Crookwell 2 Wind Farm Section 75W Modification Application Response to Submissions

On behalf of
Crookwell Development Pty Ltd
June 2017

Figure 3: Site Infrastructure Map
Source: Crookwell Development Pty Ltd

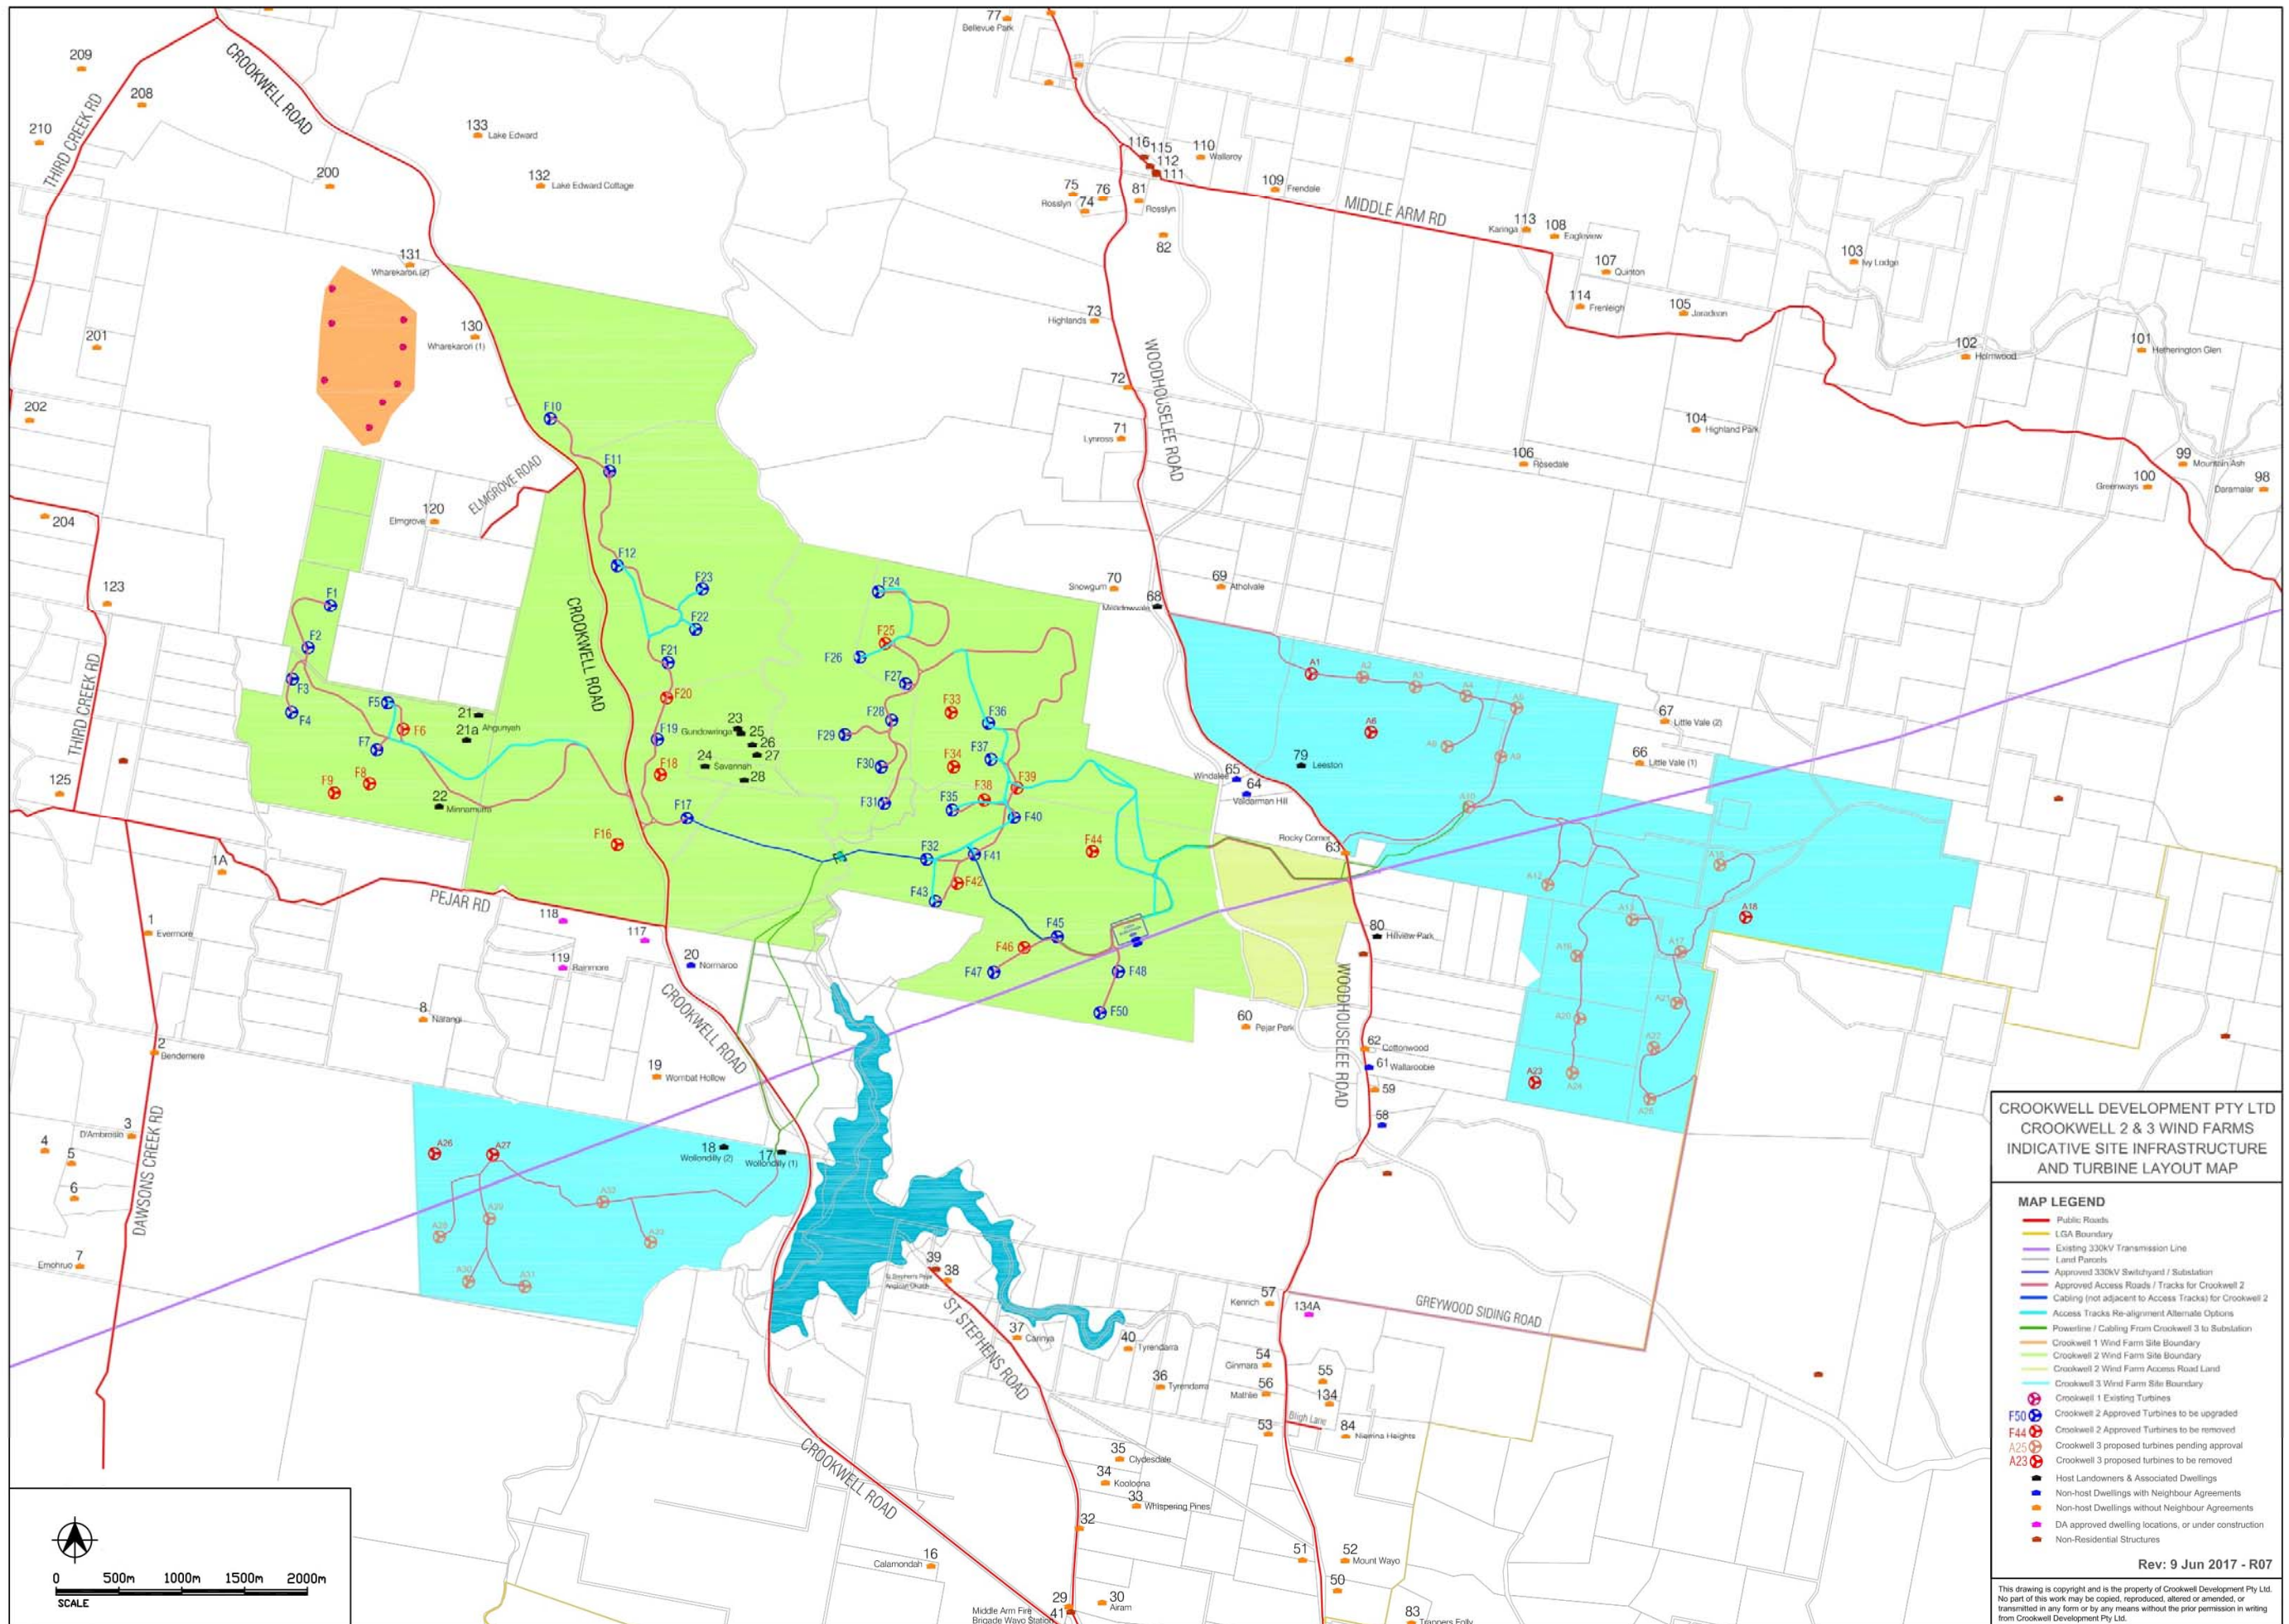
Modification 2 has now been updated to address the issues raised in submissions and as a result of further detailed design of the project. This Report accordingly clarifies the project layout further by:

The amended Site Infrastructure Layout Plan is provided at Figure 3 below which incorporates these additional clarifications. This plan remains subject to the proposed 50m micro-siting allowance which is required to allow for further detailed design as construction of the project progresses.
